Development Review Board Panel A Meeting August 10, 2020 6:30 pm

- IV. Citizens' Input:
- V. Consent Agenda:
 - A. Approval of minutes of the May 11, 2020 DRB Panel A meeting
- VI. Public Hearings:
 - A. Resolution No. 380. Frog Pond Ridge Subdivision: Li Alligood, AICP, Otak Representative for West Hills Land Development, LLC Applicant. The applicant is requesting approval of an Annexation and Zone Map Amendment from Rural Residential Farm Forest 5-Acre (RRFF-5) to Residential Neighborhood (RN) for approximately 15.93 acres of property located on the west side of Stafford Road south of SW Frog Pond Lane, and adopting findings and conditions approving a Stage I Preliminary Plan, Stage II Final Plan, Site Design Review of parks and open space, Tentative Subdivision Plat, Type C Tree Plan, Waiver to Minimum Front Setback, and Abbreviated SRIR Review on 16.25 acres for a 71-lot single-family subdivision. The subject site is located on Tax Lots 1500 and 1700, a portion of 1800, and a portion of Stafford Road right-of-way, Section 12D, and a portion of Tax Lot 400, Section 12DD, Township 3 South, Range 1 West, Willamette Meridian, Clackamas County, Oregon. Staff: Cindy Luxhoj

Case Fil

STREET CROSS SECTIONS

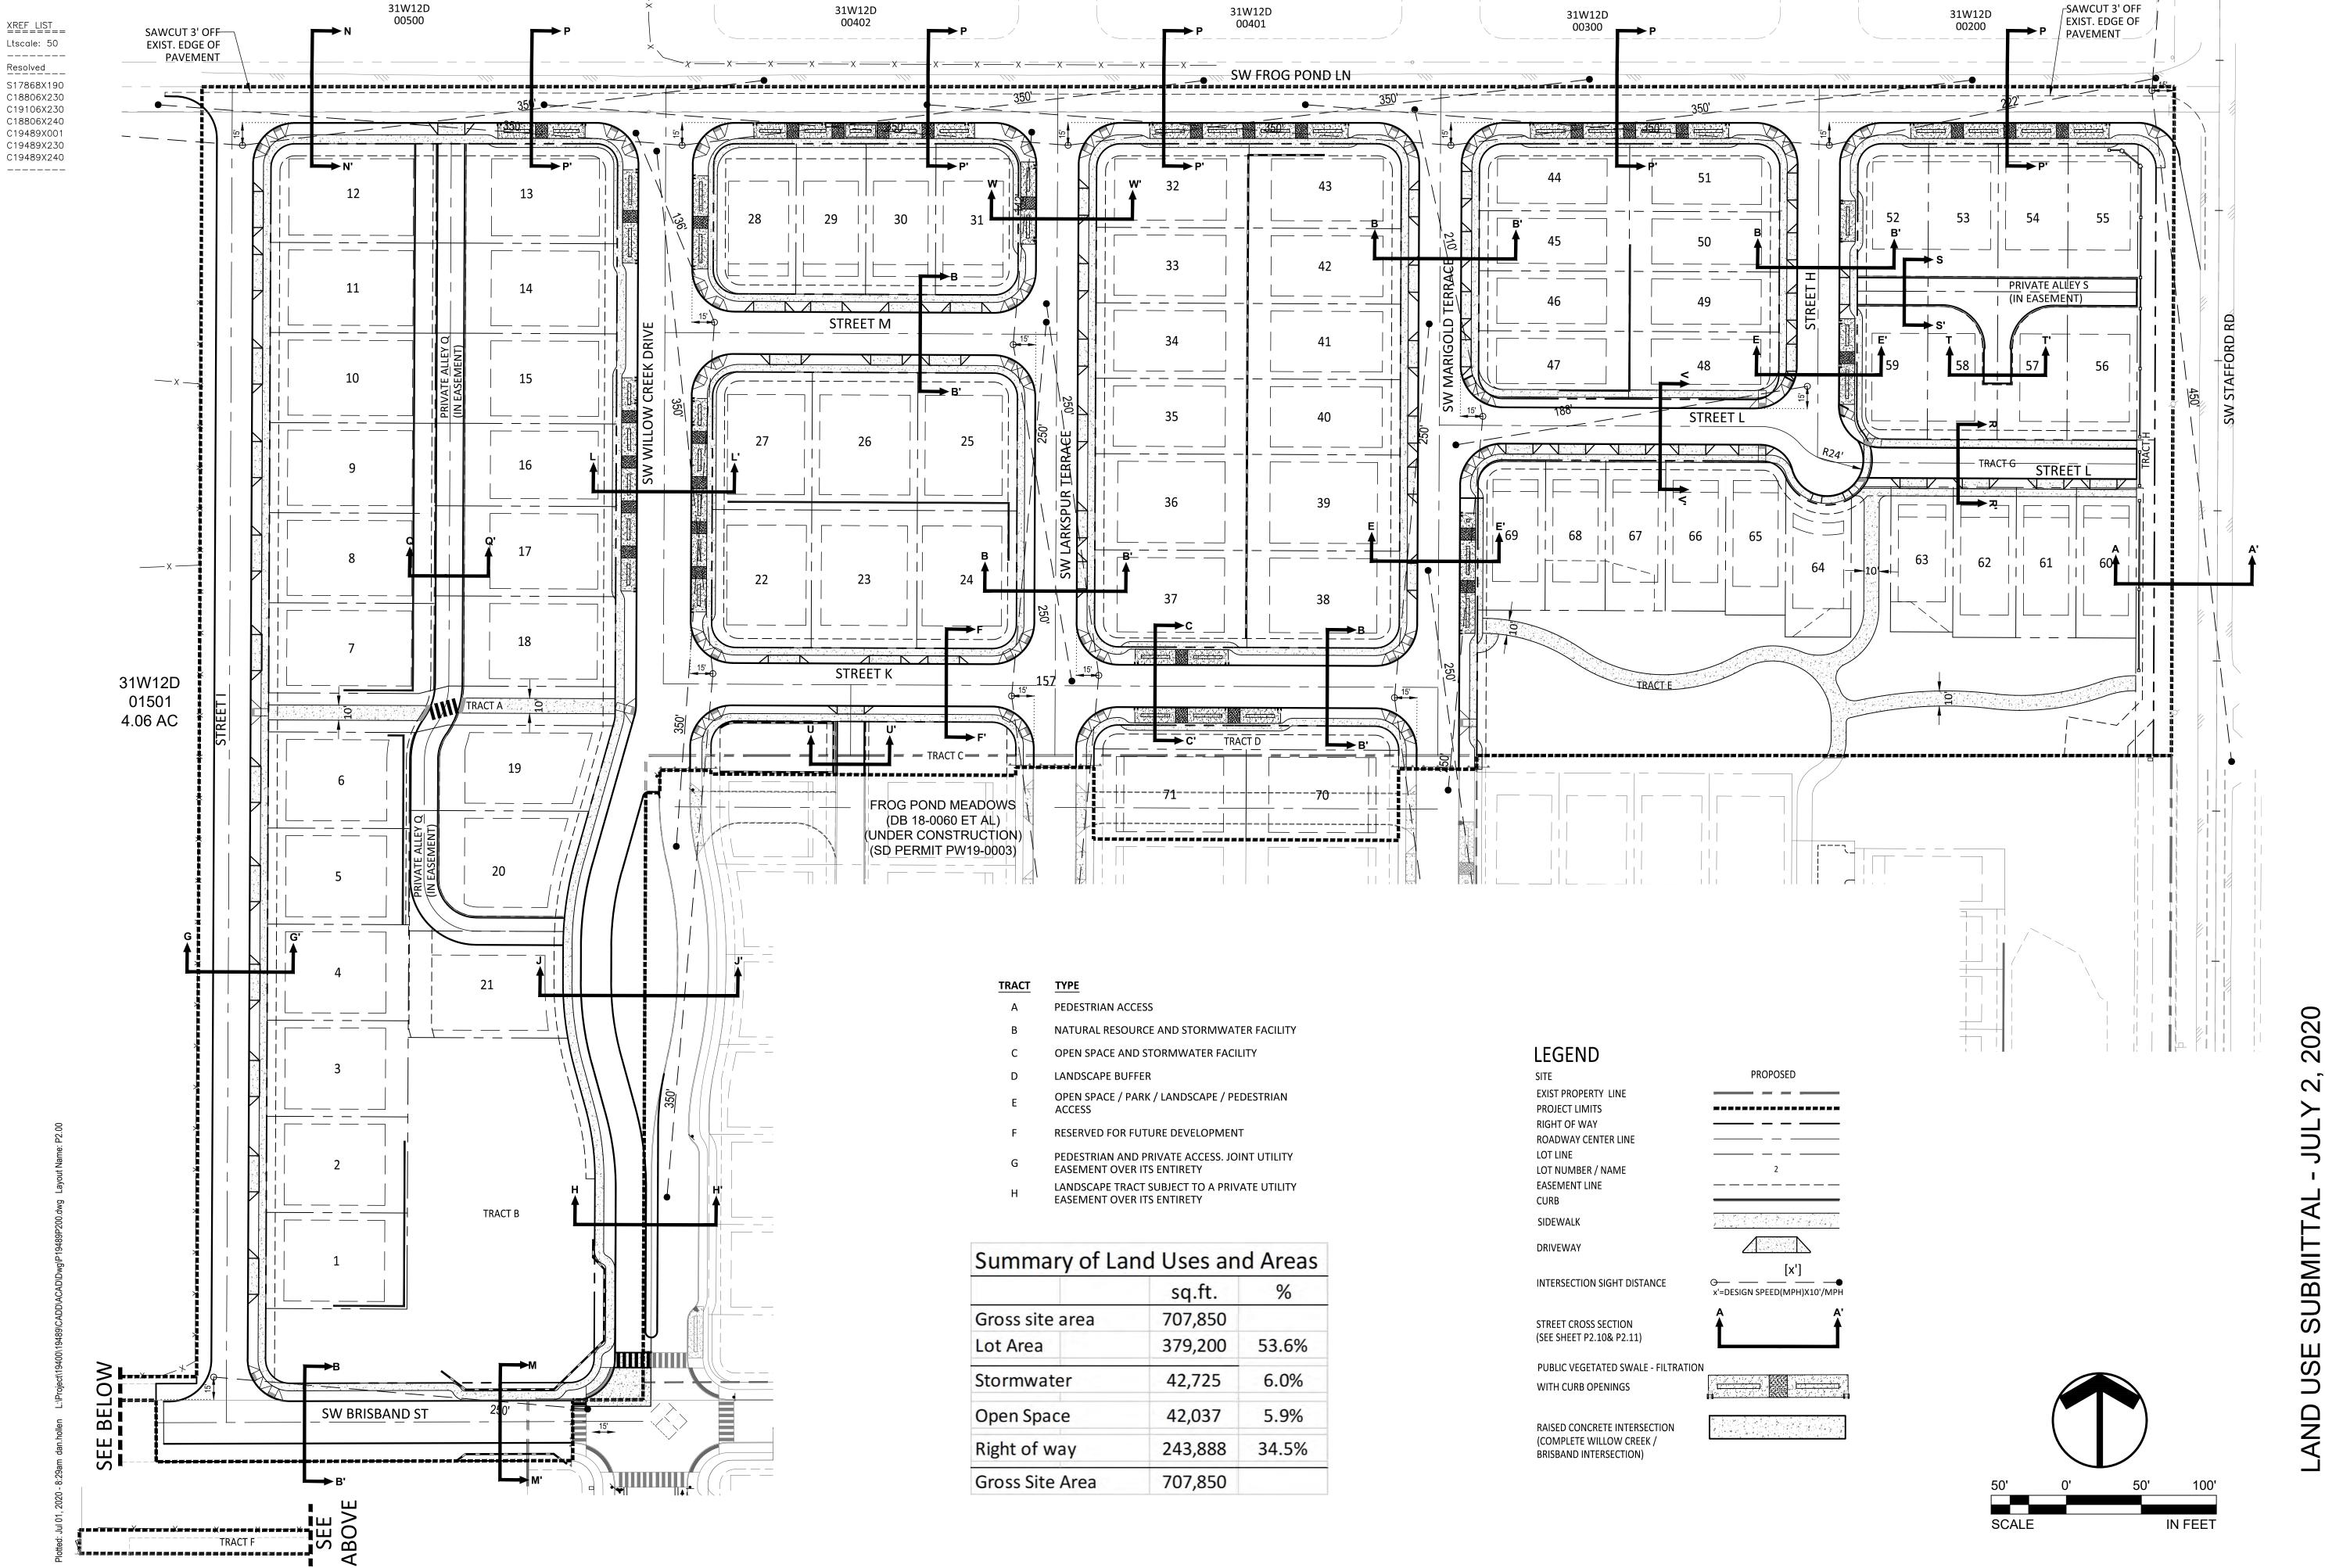
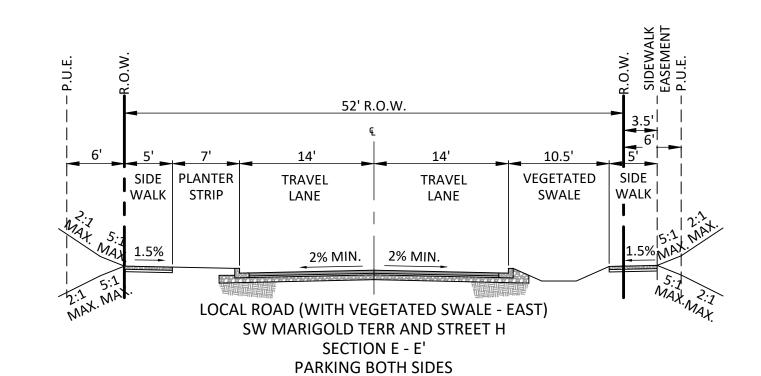
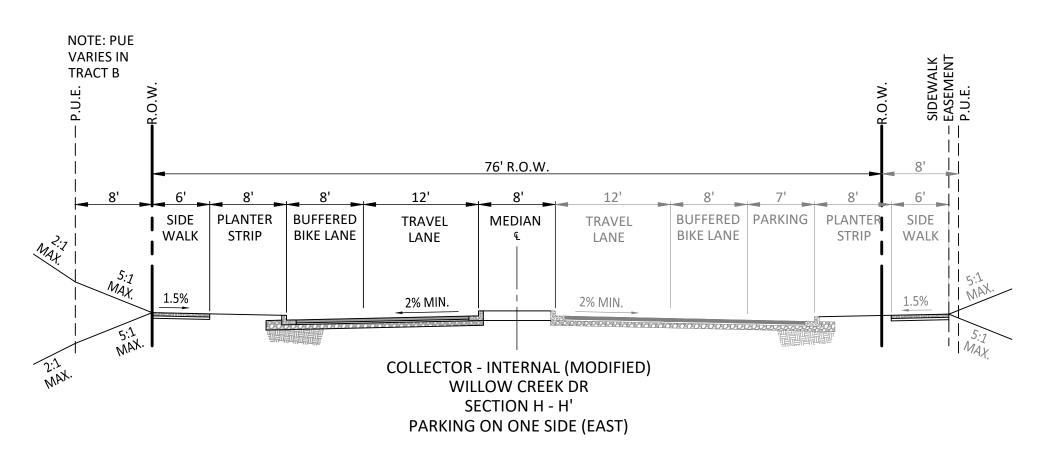
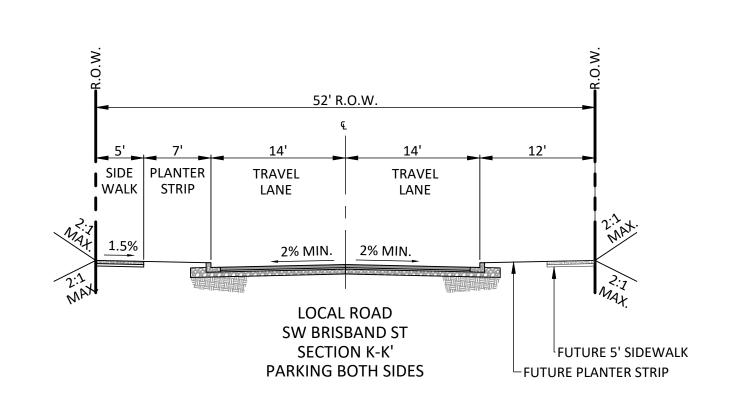
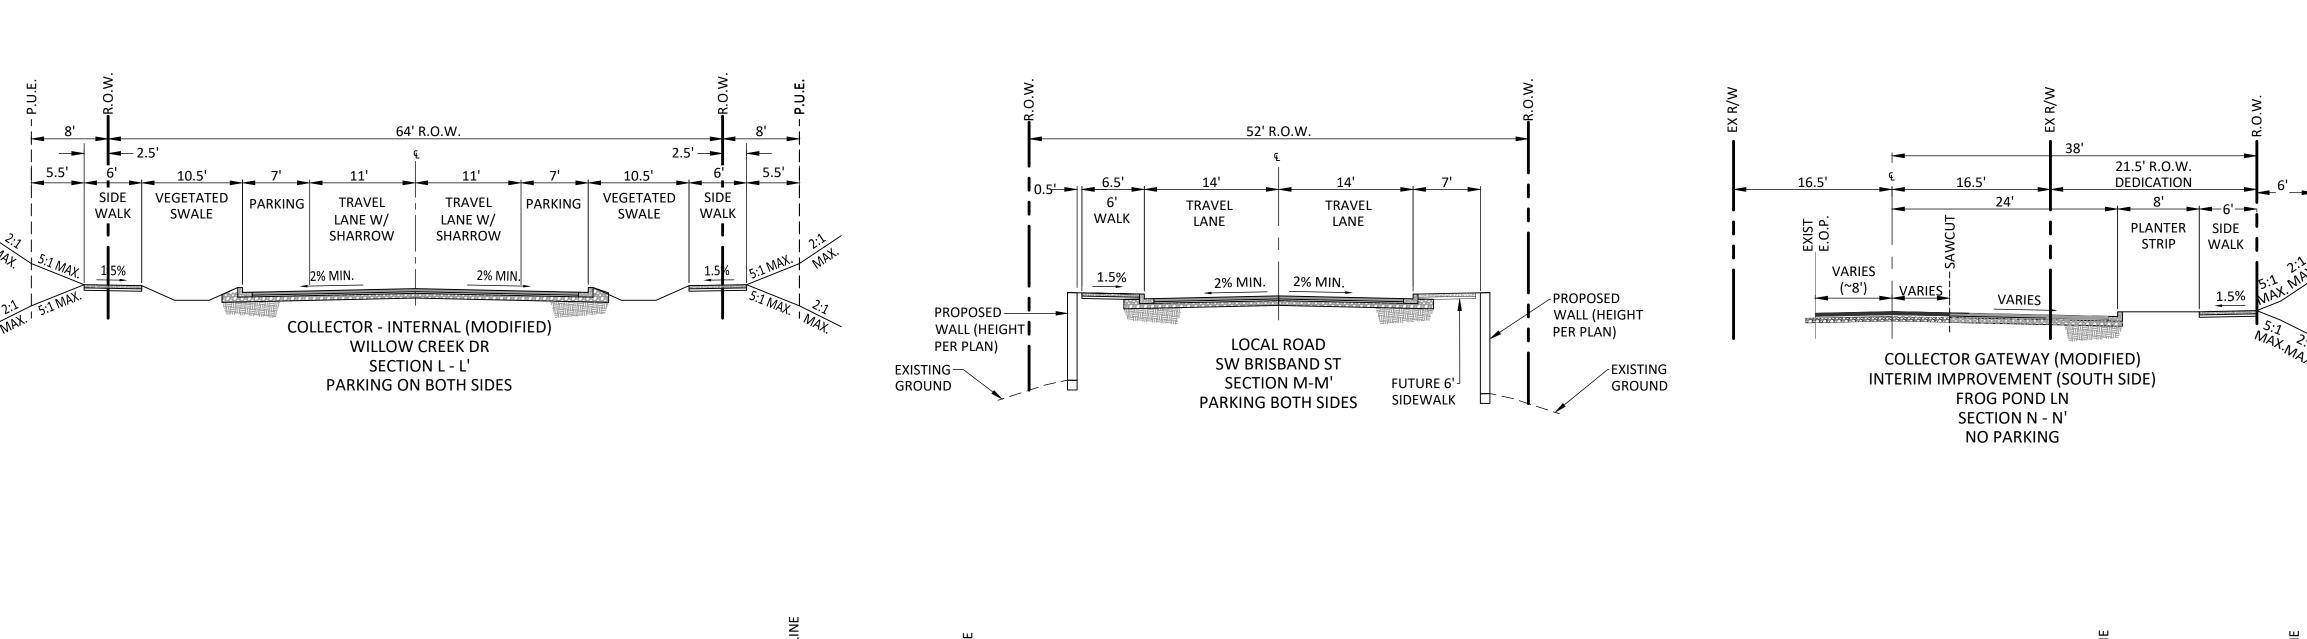
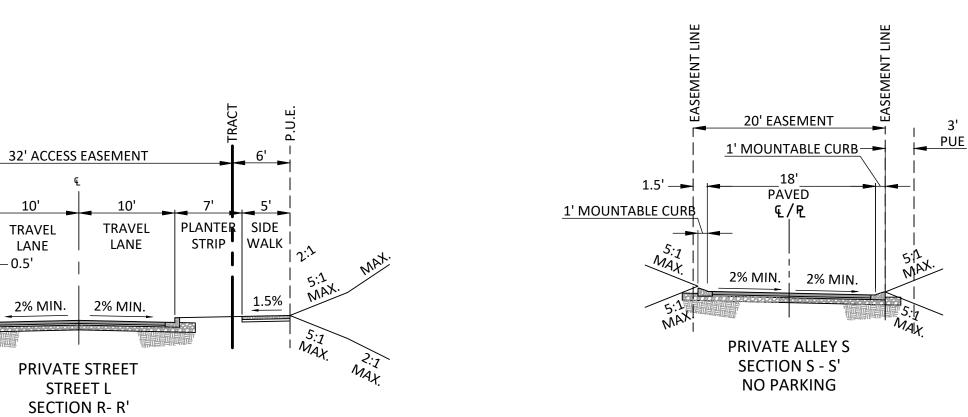
I have reviewed and approve the Applicant's requested changes to the cross-sections of the following proposed street cross sections, and as shown in the attached sheets P2.00, P2.10 and P2.11.

- a. Cross-section of Willow Creek Drive between Brisband Street and Street K to allow for preservation of a 34" white oak tree within a widened median and to allow a western partial street improvement.
- b. Cross section of Street K between Larkspur Terrace and Willow Creek Drive to allow the stormwater facility in Tract C to expand slightly.
- c. Cross section of Street L between Marigold Terrace and Street H to preserve trees in Tract E
